Access Compliance Report

Public Rights-of-Way

Intersection ID: 11877	Main Street: BILLY_GRAHAM_PY	Cross Street: N/A	Location: SW
ADA ID: C824303AF95C	Ramp Type: Perp	Initial Pass/Fail: Fail	Overall Compliance: No
Codes/Mitigation Info/Possible Solution		Field Measurements/Component Compliance	
Severity Score: 13.75

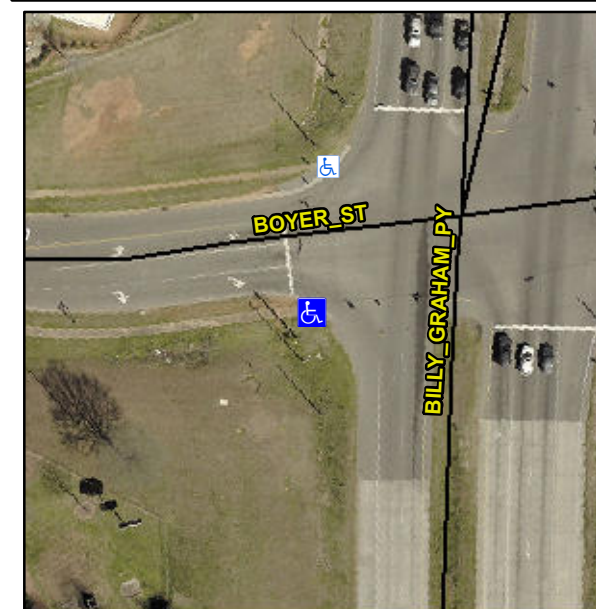
Not Found, R304.2.2, R304.5.3

Compliance	Description	Data	Compliance	Description	Data
N/A	Ramp Length (in)	64.0	No	Ramp Slope (%)	10.4
Yes	Ramp Width (in)	48.0	No	Ramp XSlope (%)	4.1
N/A	Flare Type LT	N/A	N/A	Flare Type RT	N/A
N/A	Flare Slope LT (%)	N/A	N/A	Flare Slope RT (%)	N/A
N/A	Flare Traversable LT?	N/A	N/A	Flare Traversable RT?	N/A
N/A	Landing Length (in)	N/A	N/A	DWS Provided?	N/A
N/A	Landing Width (in)	N/A	N/A	DWS Contrast?	N/A
N/A	Landing Slope (%)	N/A	N/A	DWS Length (in)	N/A
N/A	Landing X Slope (%)	N/A	N/A	DWS Full Width?	N/A
N/A	Landing Curb? (Y/N)	N/A	N/A	DWS Offset (in)	N/A
N/A	Shared Landing?	N/A			
N/A	Gutter Ponding?	N/A	N/A	Gutter Slope (%)	N/A
N/A	Gutter Lip Ht (in)	1.0	N/A	Gutter X Slope (%)	N/A
N/A	Painted X Walk1?	No	N/A	Painted X Walk2?	N/A
	X Walk 1 Direction	To NE		X Walk 2 Direction	N/A
N/A	X Walk 1 Width (in)	N/A	N/A	X Walk 2 Width (in)	N/A
	X Walk 1 Slope (%)	3.8		X Walk 2 Slope (%)	N/A
	X Walk 1 X Slope (%)	0.7		X Walk 2 X Slope (%)	N/A

Remove & Replace Entire Ramp.
